This Service Information bulletin supersedes SI B12 18 14 **dated October 2014**.

Engine Misfire Due to Failed Ignition Coil

With the N51, N52, N52K, and N52T engines

Ignition Coil Identification

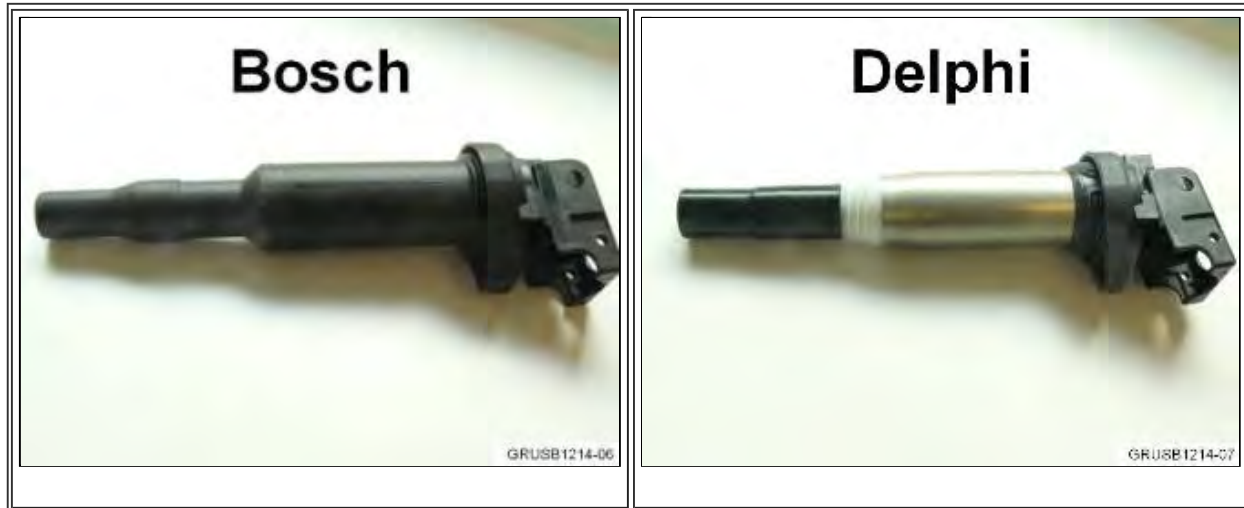
1. **NEW** For vehicles with the **N51, N52, and N52K** engines which have been in service for over 24 months or 10,000 miles: during the first service visit due to an ignition coil failure, replace **all Bosch** ignition coils with **Delphi** coils as indicated in ETK (March 2015).

NEW If any ignition coil(s) was replaced previously with a **Delphi** part, it does **NOT** need to be replaced.

2. For the F10 and F25 with the **N52T** engine, replace **all Bosch** ignition coils with the replacement **Delphi** coils under these situations:
